# AMENDMENT REPORT

## Tilbuster Solar Farm

Project Number: 20-729

Figure 4-1 Amended infrastructure layout

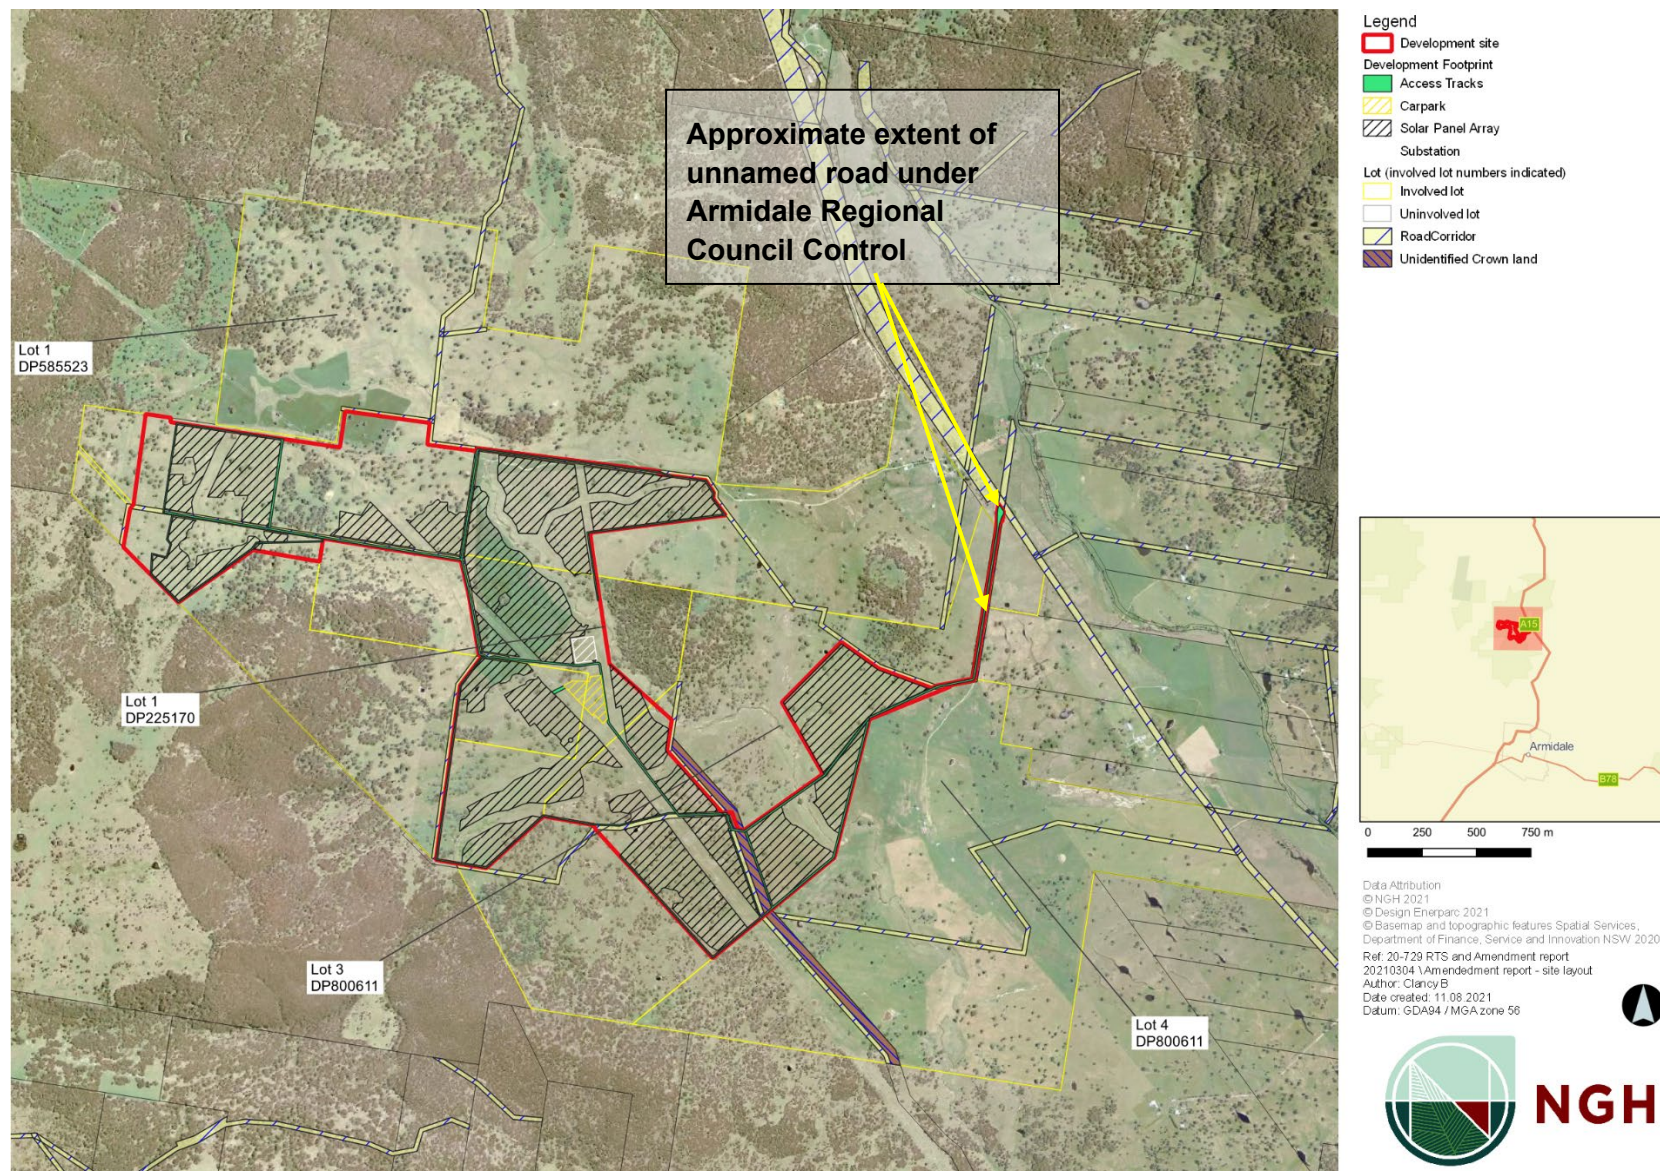
2. Submissions received from Council identify that a section of the unnamed access road is under Council control. This is shown in Figure 4-1. The Proposal will commit to constructing the unnamed access road in accordance with the relevant Council engineering codes. Complying with these engineering codes would not require a change in the Development Footprint of the Proposal, and will improve safety and compliance with relevant guidelines during construction of the Proposal.

The EIS proposed a Development Footprint with an area of 178 ha. Enerparc is proposing an amended Development Footprint considering the comments raised during the submissions phase of the project. This consultation is presented in the Submissions Report, and in Section 2 of this report. The new layout avoids a larger area of BGW SAI and provides additional space to construct the intersection upgrade. To achieve reduction in BGW SAI, stream buffers that were previously avoided, were utilised within the Development Footprint. As a result of this footprint change the total area of development has reduce from 178 ha to 169.7 ha.

The amended Development Footprint is shown in Figure 4-1. An updated constraints figure showing the amended Development Footprint and key environmental constraints is shown in Figure 4-2. A figure showing where the Development Footprint has been increased and decreased, is shown in Figure 4-3.

Figure 4-3 Amended Development Footprint in comparison to the EIS Development Footprint, showing additions and subtractions.

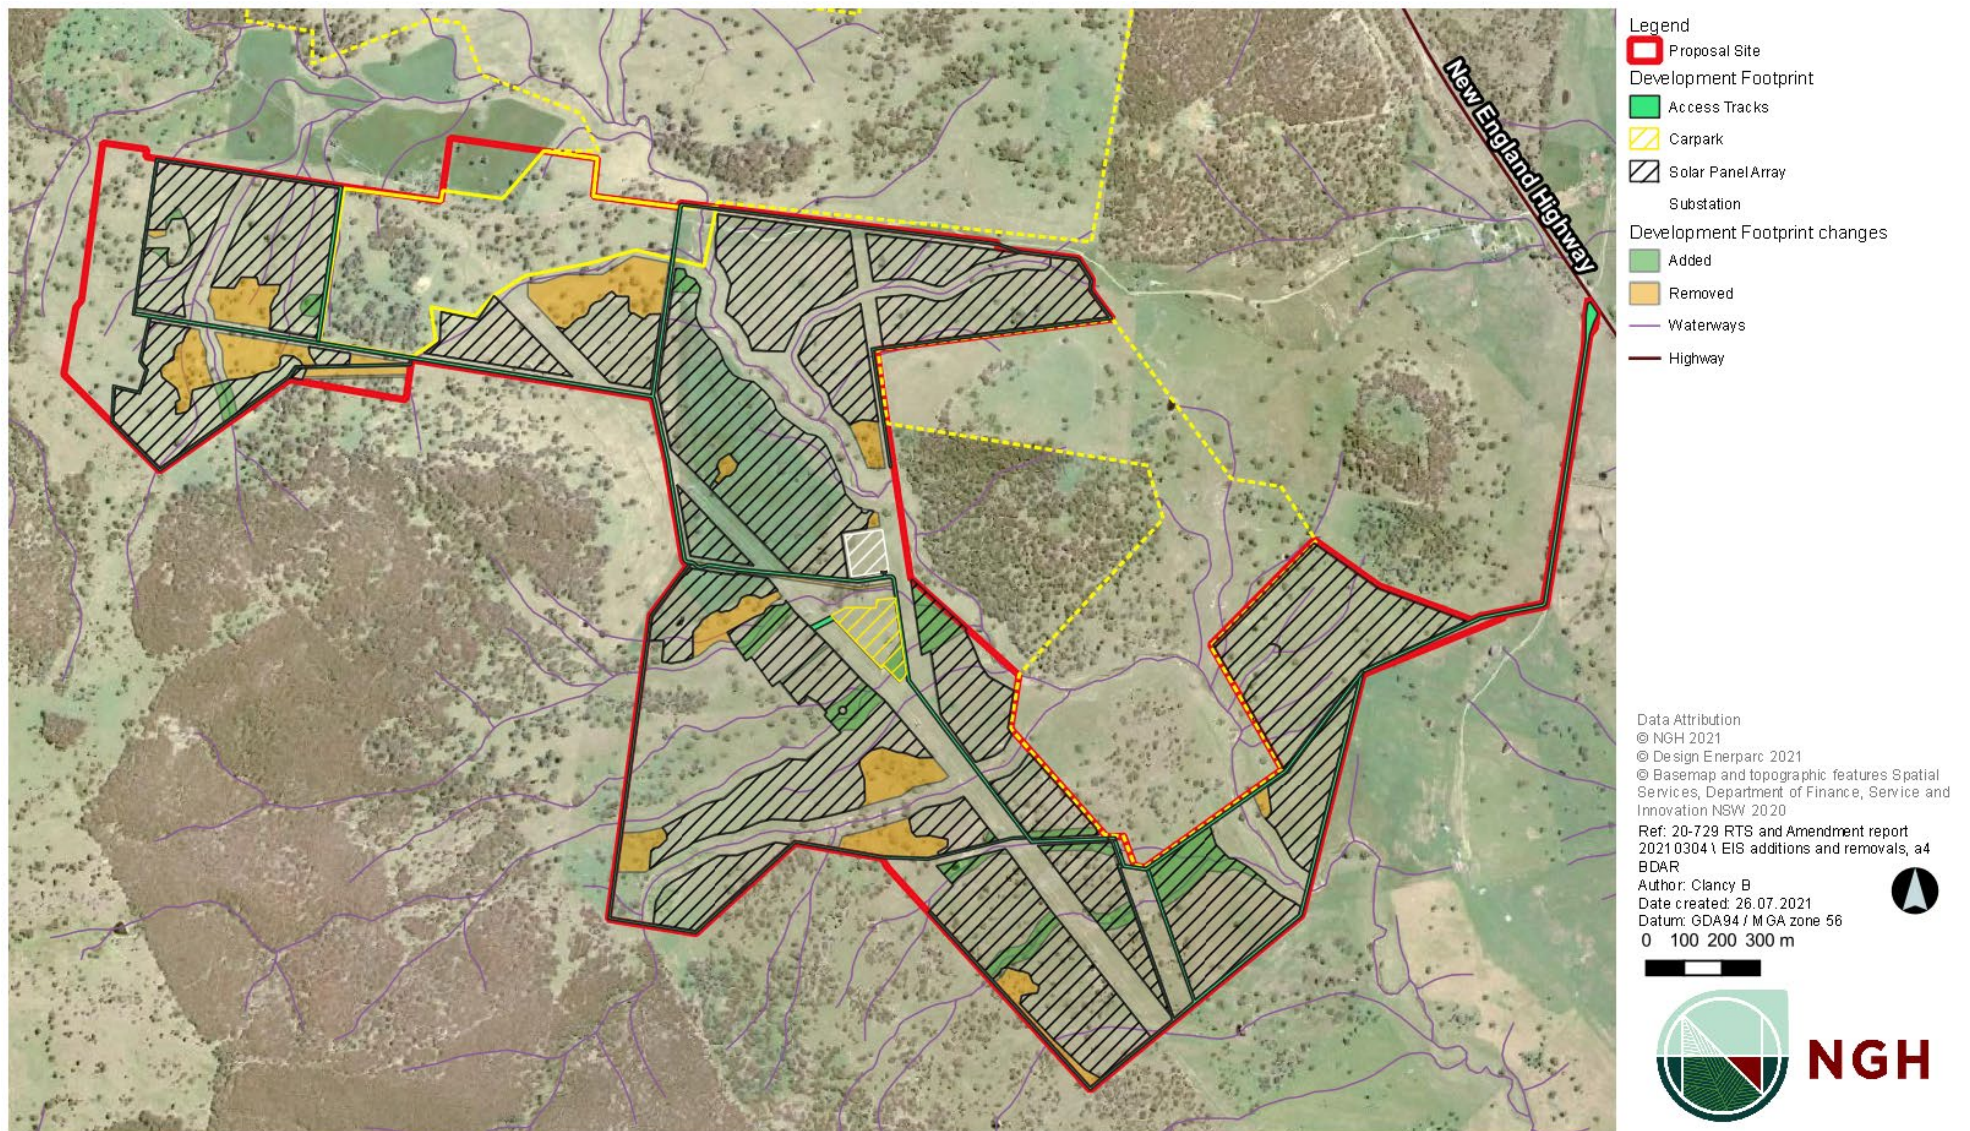
The Development Footprint of the proposal has been refined, from the footprint identified in the EIS. This refinement involves a net reduction in impact area from 178 ha to 169.7 ha. The reasons for the change are:

Figure 4-4 New England Highway / unnamed Council access road intersection concept design

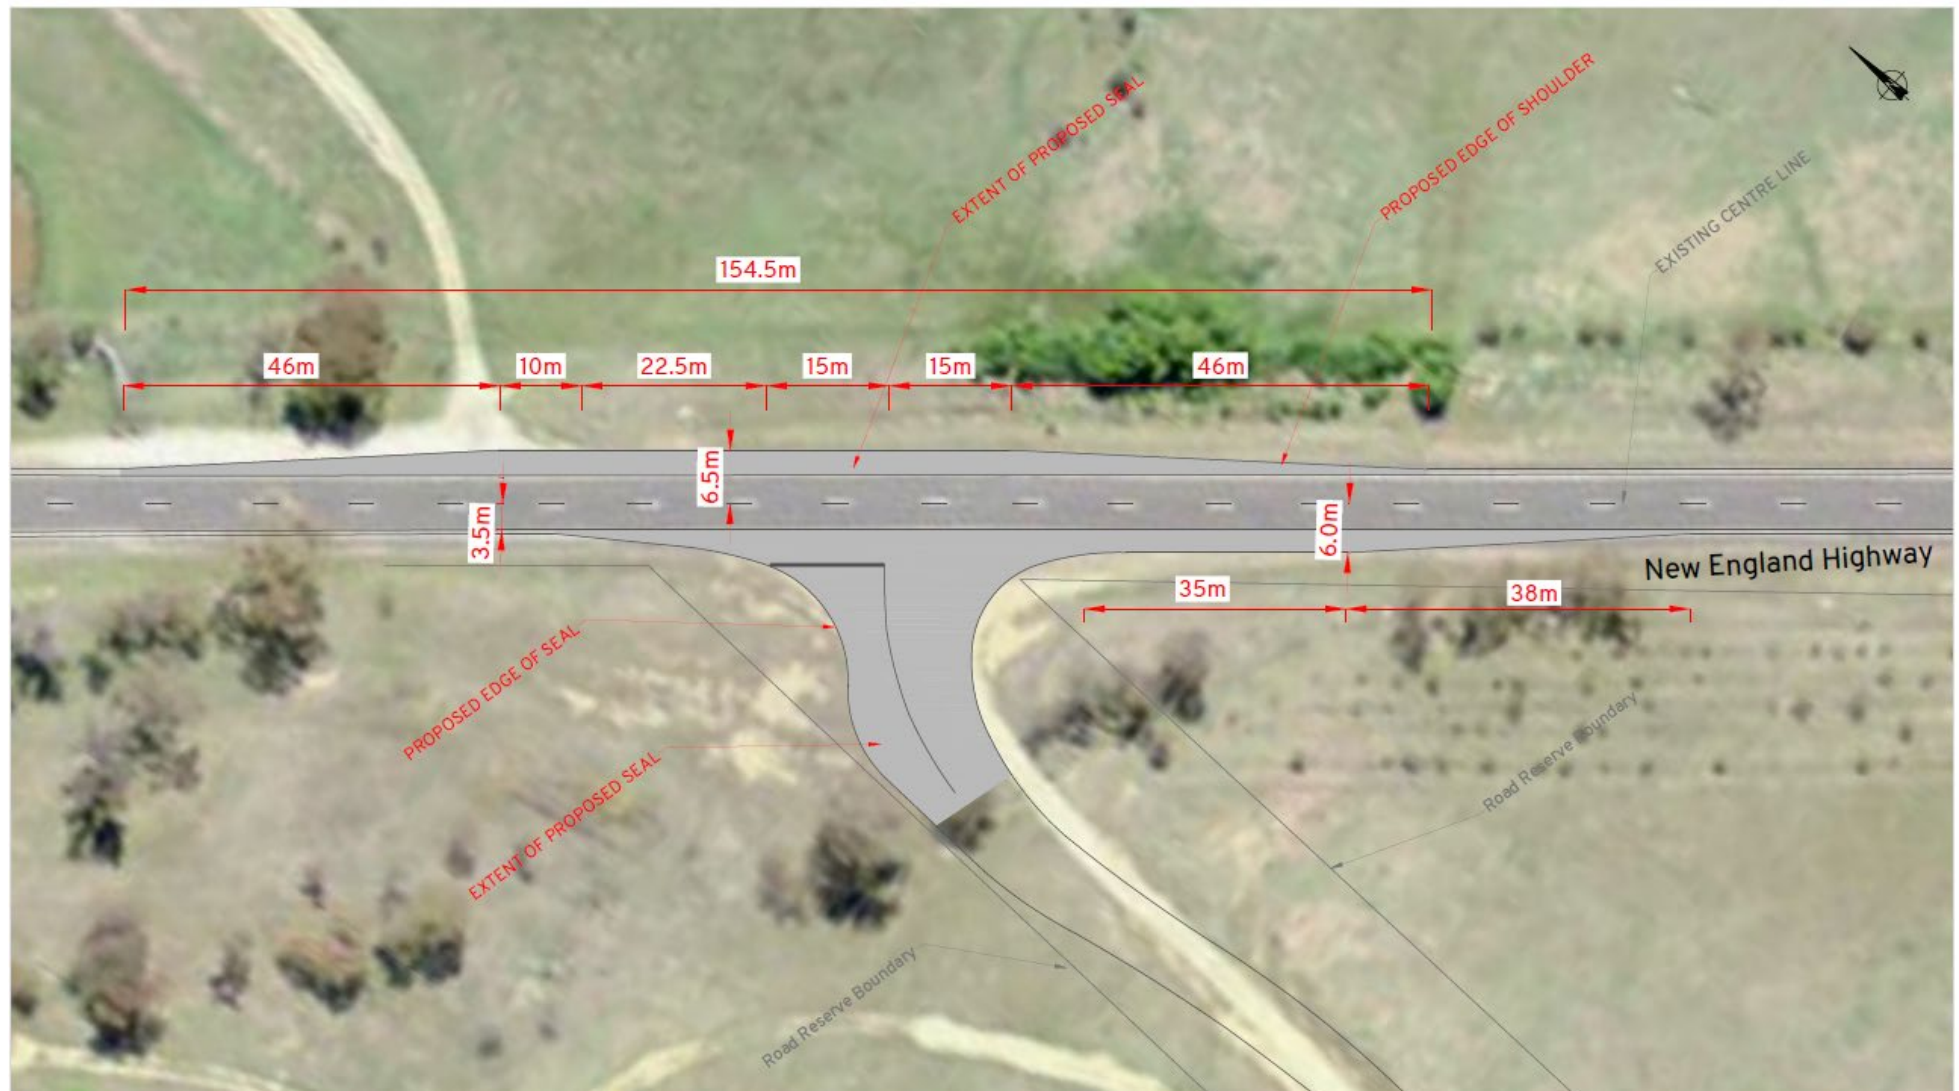
In response to comments from TfNSW, an amended intersection upgrade design at the unnamed Council road/New England Highway intersection has been developed. As part of the design process, a swept path analysis of B-doubles entering and exiting the Development Site was completed, to ensure the intersection would be safe and efficient for the proposed construction delivery vehicles. The changes to the intersection involve increasing the width of the paved area to allow more space for concurrent access and egress of B-Double vehicles. The amended intersection, including Basic Left Turn (BAL) and a Basic Right Turn (BAR) treatments, meet the requirements of the *Austroads Guide to Traffic Management Part 6: Intersections, Interchanges, and Crossings* (Austroads, 2017). The amended intersection upgrade concept design is shown in Figure 4-4. In accordance with these changes, an updated concept design has been prepared and is shown in Figure 4-4. Figure 4-5 shows the swept path analysis for a B-Double vehicle.

Figure 4-6 Indicative oversized overmass vehicle arrangement

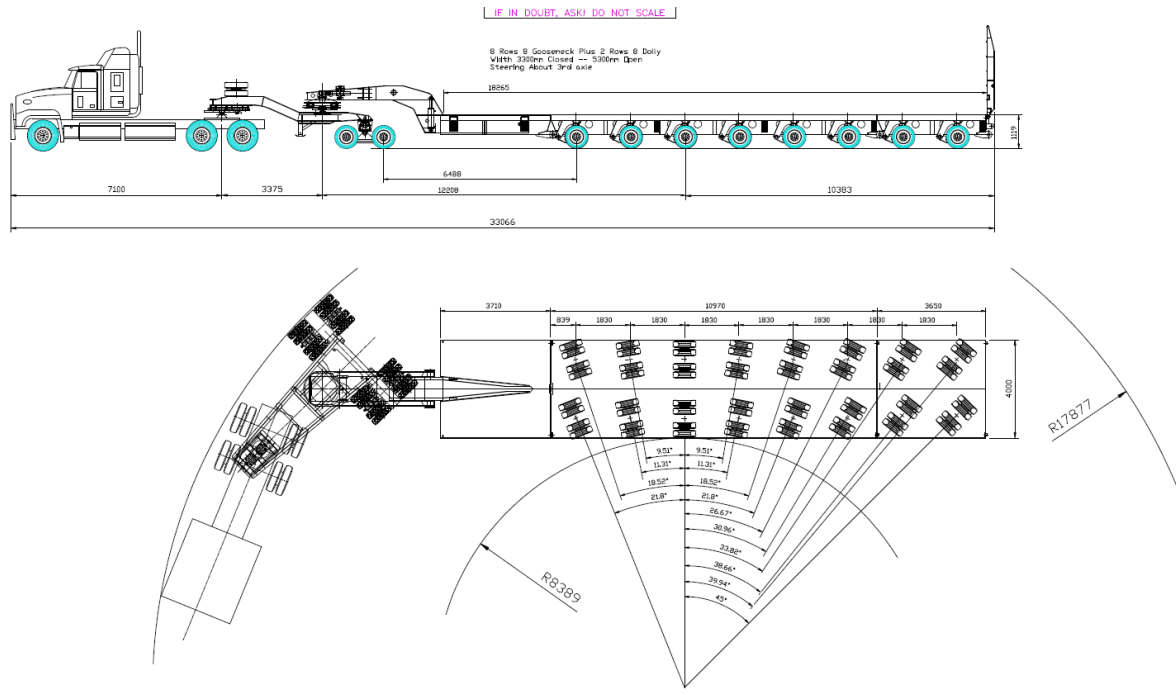
In response to consultation with DPIE, further consideration has been given to the OSOM vehicle arrangement. The EIS identified that a single OSOM vehicle would travel to the site to deliver a substation unit. However, the arrangement of that vehicle wasn't defined in the EIS. Based on early construction planning, it is anticipated that a vehicle similar to the one shown in Figure 4-6. The final vehicle selected would depend on the detailed design and procurement arrangements. This would be confirmed post approval. None the less, the vehicle shown below is considered representative of the vehicle that is likely to be used.

Figure 5-1 Biodiversity constraints, potential offset sites and the updated amended Development Footprint following BCD consultation

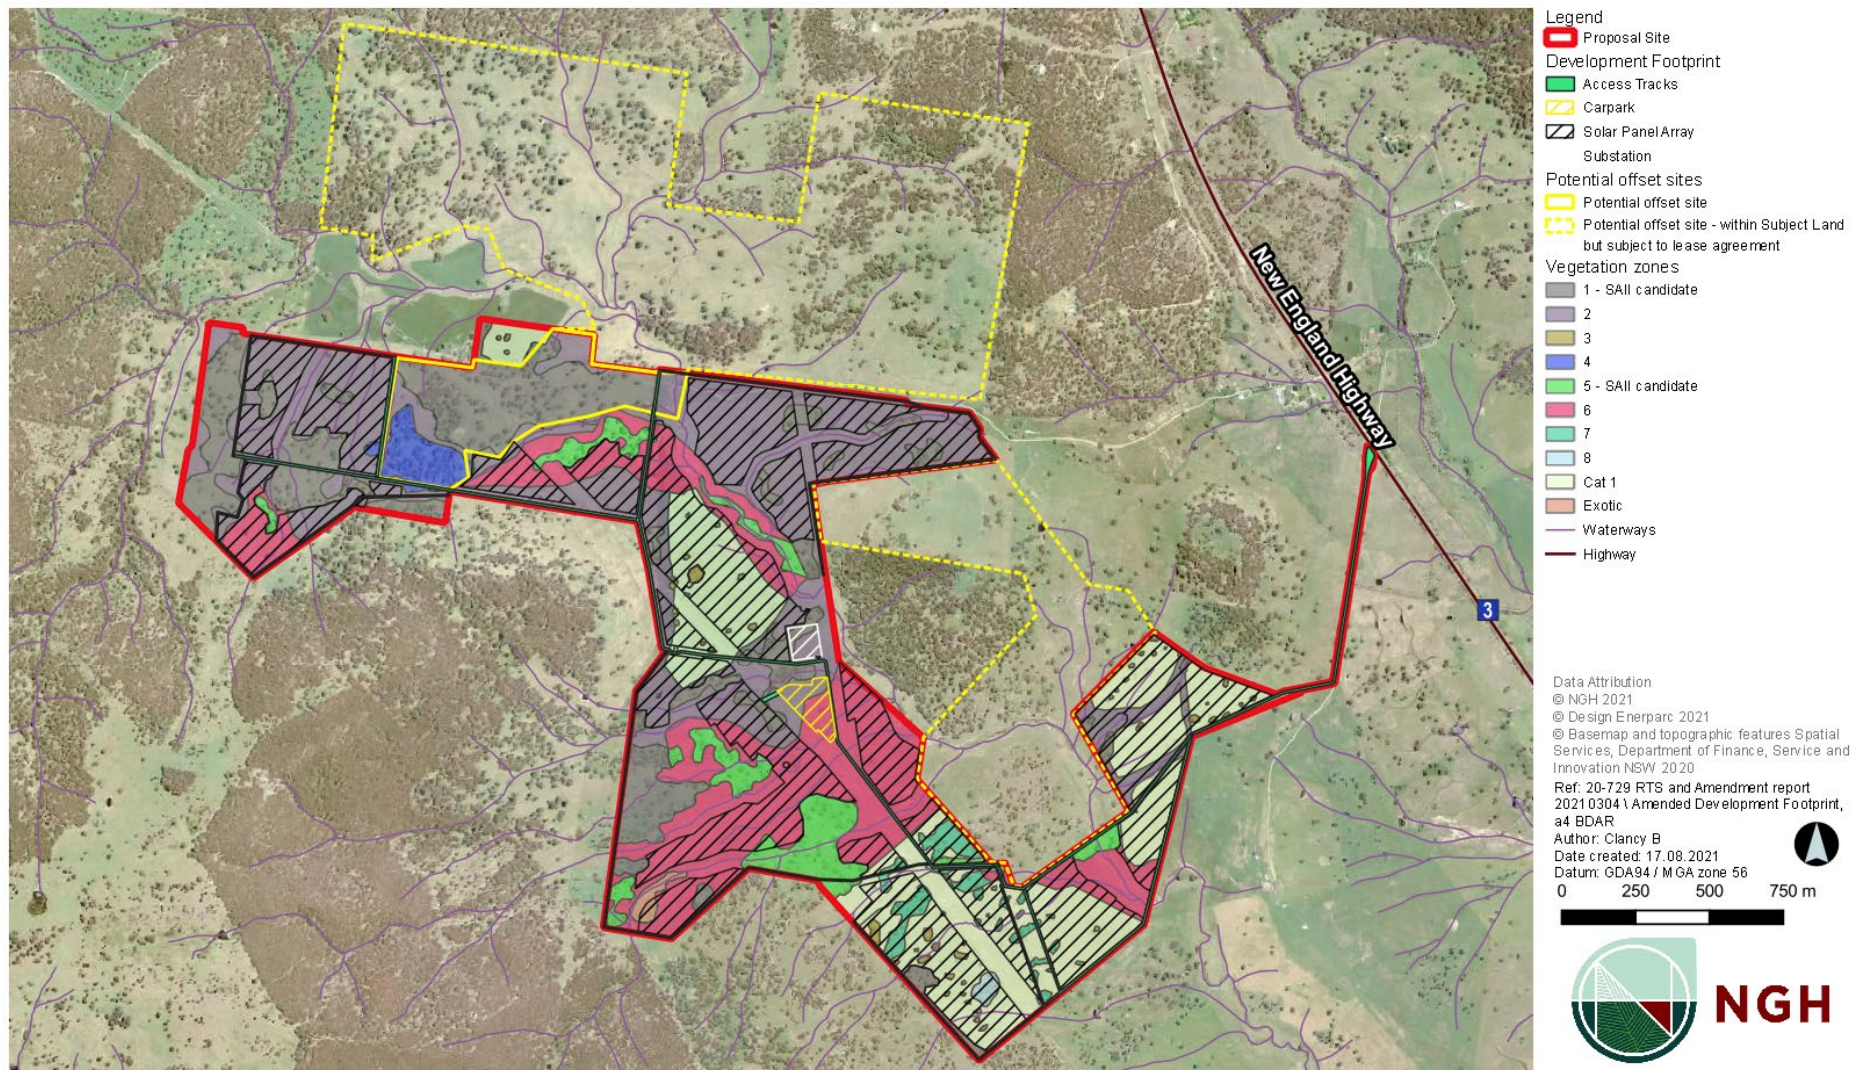
In addition, the amended Development Footprint would now impact almost 3 ha more of Category 1 land, compared to the EIS Development Footprint. Category 1 land is considered a low constraint to development as it has been extensively modified by legal agricultural practices and is exempt from most aspects of the Biodiversity Assessment Method (BAM). These changes represent a significant reduction to the potential for the Proposal to cause Serious and Irreversible Impacts. The change to the Development Footprint resulting from the expansion of the intersection with the New England Highway, would result in an additional impact of 0.10 ha of vegetation Zone 6. A comparison of the EIS footprint versus the amended footprint, including the clearing areas of each vegetation zone for both, is presented in Table 5-1.

As identified in Section 2.2 of this report, BCD have expressed that are satisfied with the refined Development Footprint presented in this Amendment report and that their concerns regarding SAIL have been adequately reflected in the updated layout.
